## PLAN COMMISSION MEETING AGENDA

TUESDAY, October 14, 2014  
AT 6:00 P.M.

# Plan Commission Report

**PROJECT:** Plan Review – Pasa Ece, Wisconsin Granite Depot

Project No. 1311500  
 Sheet No. T1  
 Of 6 Sheets

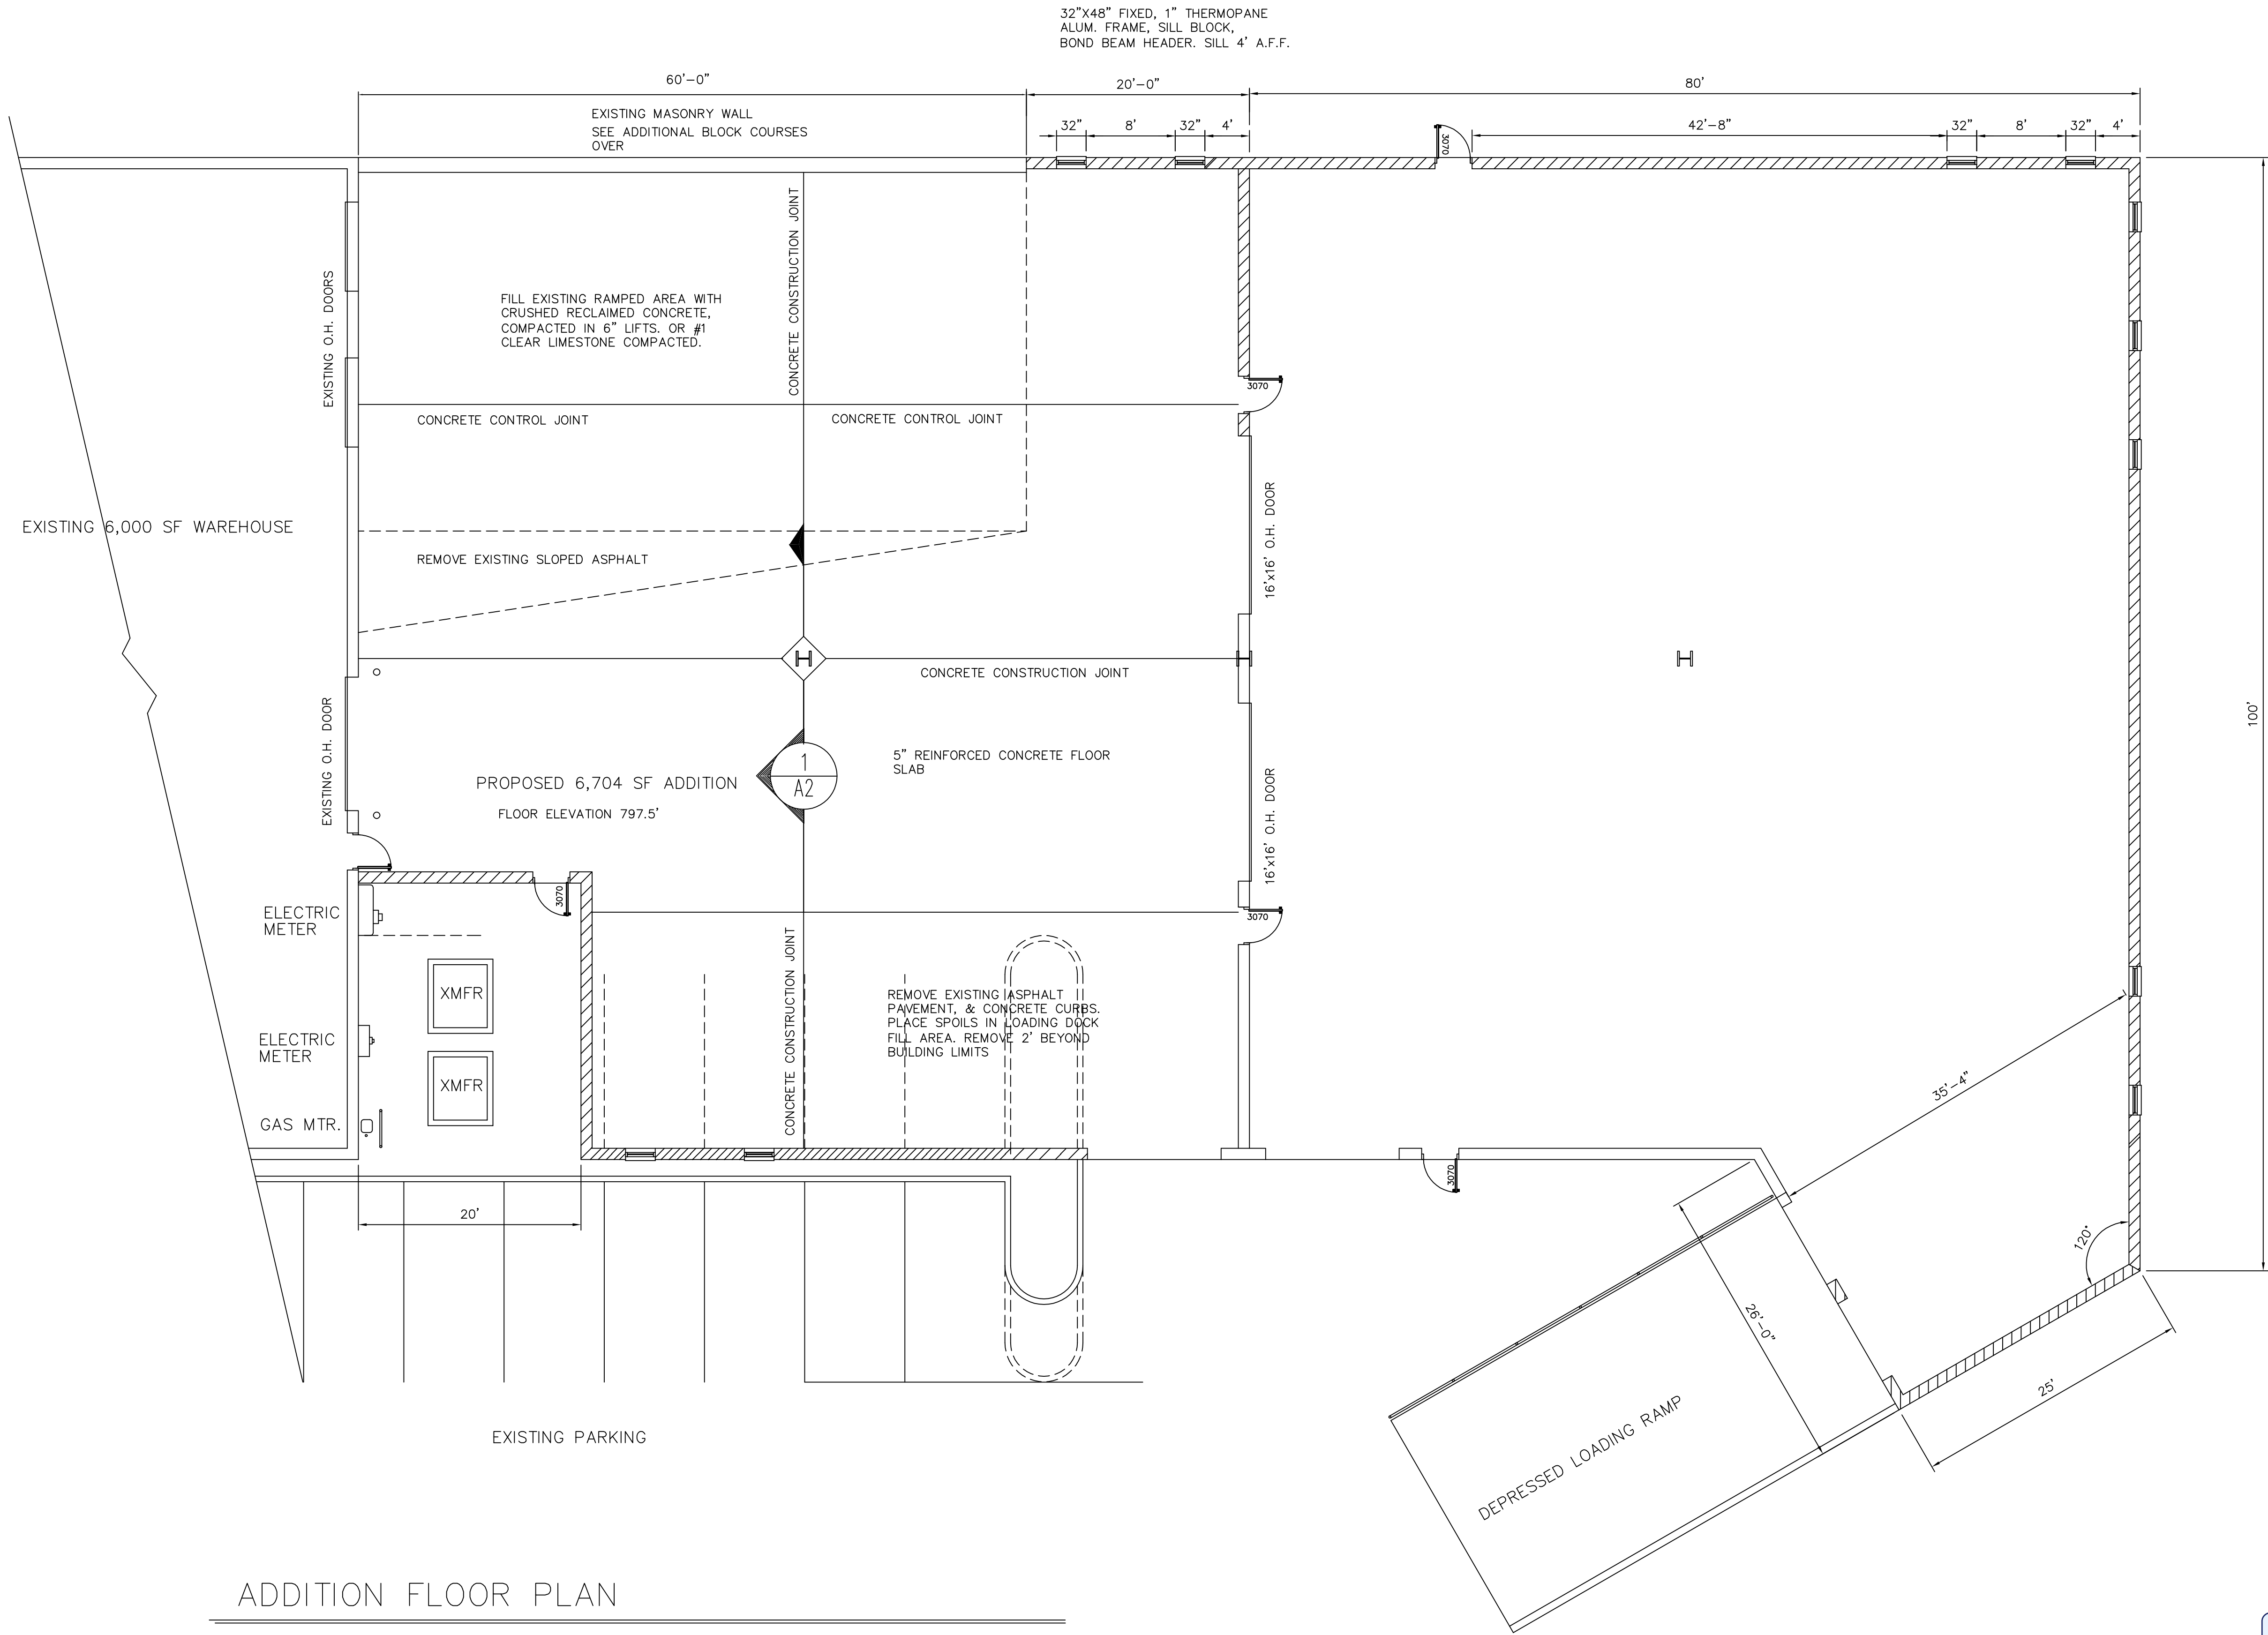
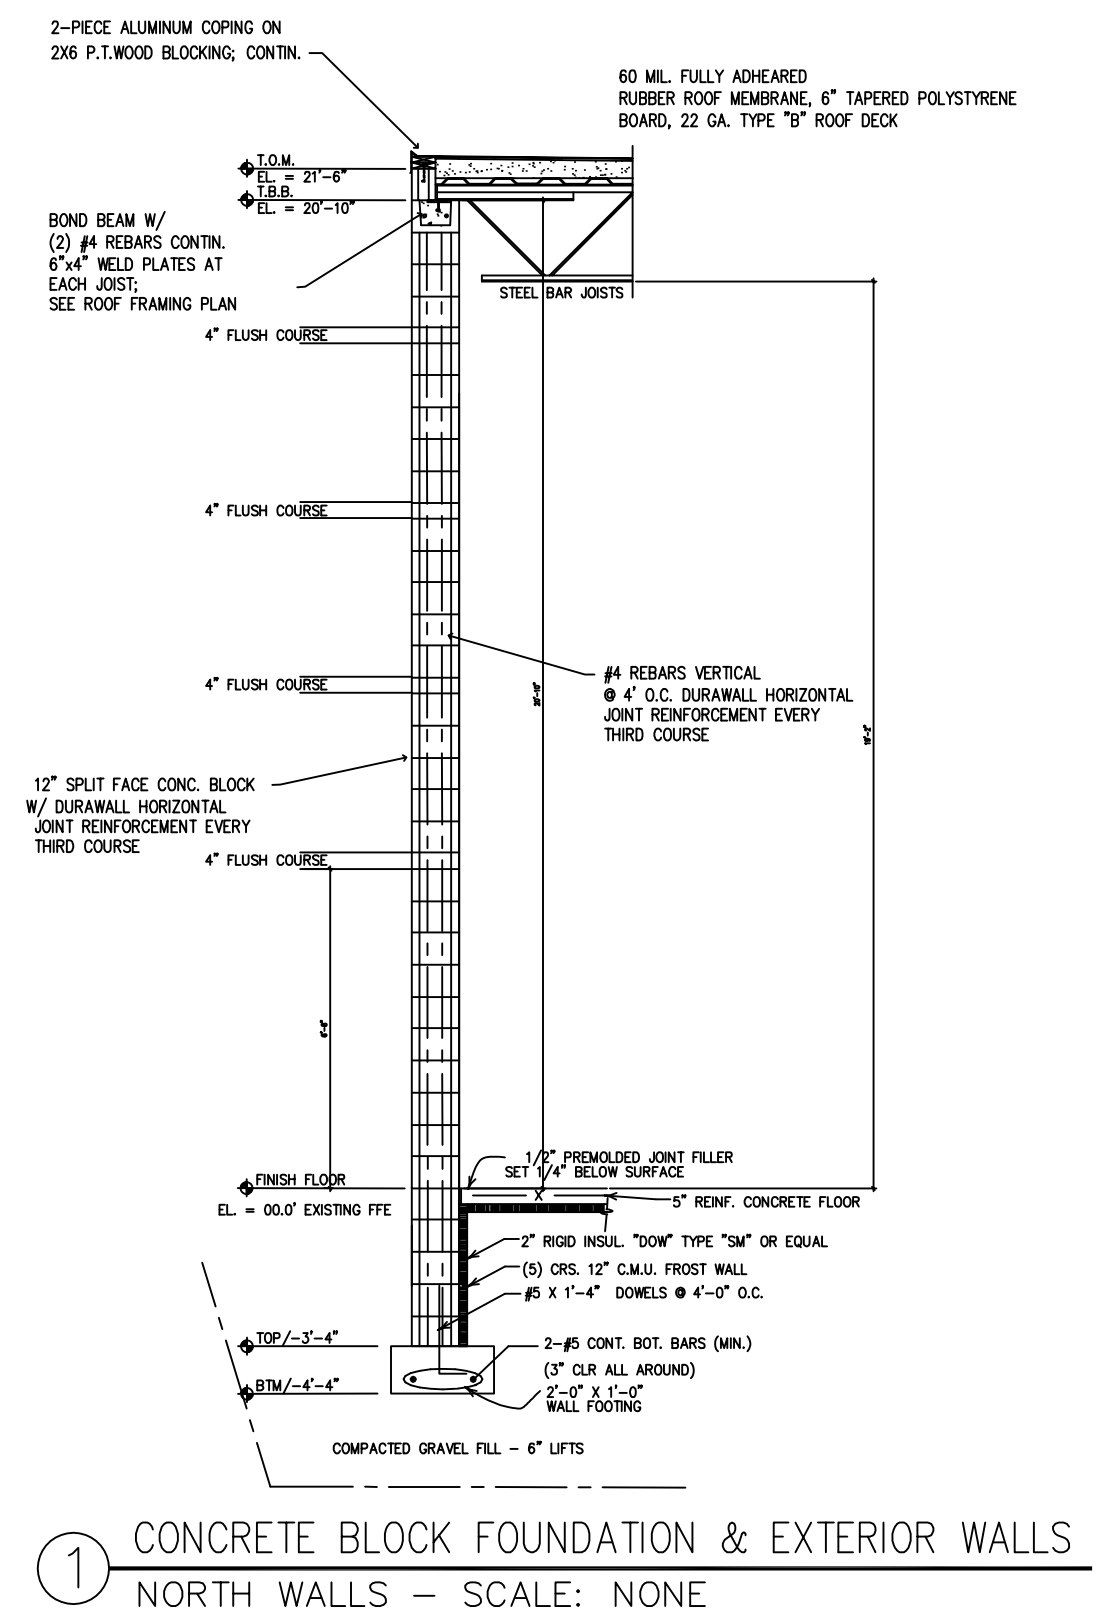
Although staff attempted to obtain the information requested by the Plan Commission, the Applicant’s architect disagreed with staff and stated that all requested information had been submitted. Items that are missing include the rendering of the proposed addition as viewed from Menard’s, and a detailed and enhanced landscape plan for the east. There are notes on the plan to reflect removal of the fencing on the north and south sides, a 4-foot-tall

CMU wall on the south side to screen the dumpsters and depressed loading dock, and a gate for the dumpsters. Included in this packet are the latest revisions to the proposed plans.

Parking on this lot is severely restricted with the proposal. During the September 23, 2013 review of the application for a fence on the property, the Plan Commission approved a reduction in the minimum parking requirement, and required a minimum of 59 stalls to remain available for parking. This was acceptable as an area was set aside for 11 future parking stalls on the northeast portion of the property at the May 23, 2000 meeting as part of the review for the original building, and there was sufficient space for additional parking on the east. At the January 14, 2014 meeting, the Plan Commission approved the construction of the 6,704 square-foot addition onto the east of the existing building. No change to the existing parking was proposed and there was still sufficient space for future parking stalls on the east. For reference, this would have required an additional 45 parking stalls according to Section 17.0403(j)(2).

Additionally, site plans must include space set aside for future parking areas in full compliance with Code requirements. If granted by the Plan Commission, this would be the third reduction in the minimum parking requirements. Staff has concerns for the limited number of parking stalls proposed and the fact that the addition leaves no room for future parking areas. There is no capacity for further expansion of the building or parking to meet Code requirements, and the lot currently does not meet the minimum 30% open space requirement. Therefore, staff recommends that the Plan Commission does not approve of the proposed addition.

1. That a minimum of 30% open space as defined in Section 17.1009(a)(21) is maintained on the property.
2. That a minimum of fifty-eight (58) parking stalls are maintained on the property.
3. That landscaping plans are submitted for review and approval by the Department of Community Development prior to issuance of permits.
4. That all building and fire codes, including required emergency vehicle turnarounds, are met. Any substantive changes to the plans will require additional Plan Commission review.

NOTE:  
A PAVED TURNAROUND IS  
REQUIRED FOR LOTS 1-3

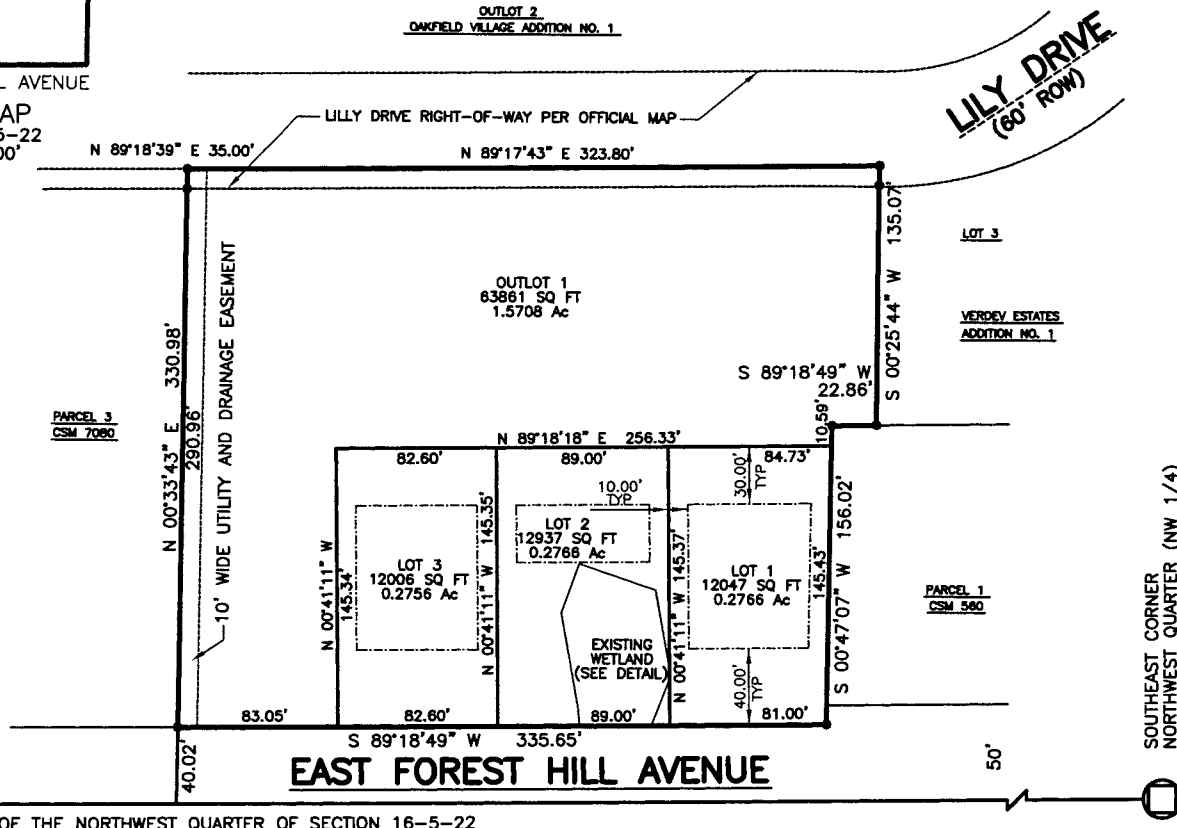
The City's adopted Comprehensive Plan designates E. Forest Hill Avenue as a minor arterial roadway and recommends managing and controlling access on arterial and collector roadways. It goes on to state that only major facilities such as large shopping centers or other significant traffic generators should be allowed direct access to arterial roadways. Staff has historically gone on record with concerns regarding single-family lots each taking direct access to arterial streets. However, in this instance, the officially mapped street pattern leaves no realistic alternative. In this case, considering the increasing traffic on the street and its minimal cross section, Staff recommended in 2013 that a restriction be placed on the CSM requiring a paved turnaround area on each of the lots to avoid vehicles having to back out into the traffic lanes of the minor arterial street. This is depicted as a note on page 1.

1. That all technical corrections are made prior to recording.
2. That the utility and drainage easement along the western property line of the proposed Outlot 1 is updated per the requirements of the Water and Sewer Utility and Engineering Department prior to recording.
3. That a detailed grading plan is submitted for review and approval by the City of Oak Creek Engineering Department prior to recording.
4. That a paved turnaround area be required on all building lots.
